SERVICE BULLETIN

HARLEY-DAVIDSON

M-932 June 6, 1986

FLST FRONT FORK LUBRICATION

Figure 1. FLST Fork Tube Configuration Plug

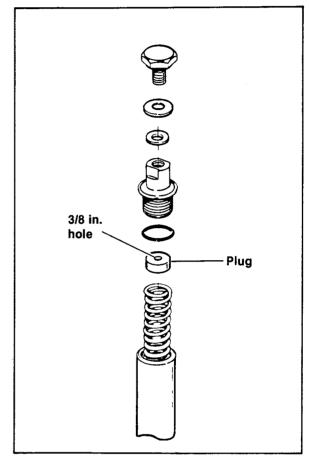
See Figure 1. The 1986½ and later FLST front fork tube configuration is similar to the FXST, except that a plug was added to preload the fork spring.

A few of the early FLST's were manufactured with an undrilled plug that must be removed to add fork oil. As a product improvement, all later forks have longer springs and no plugs.

If you service an FLST with the undrilled plugs, drill a 3/8 in. hole in them to make future fork oil changes easier.

The plug preloads the fork spring. Dissassemble the fork tube(s) carefully. The spring can force parts from the tube unexpectedly, possibly causing personal injury.
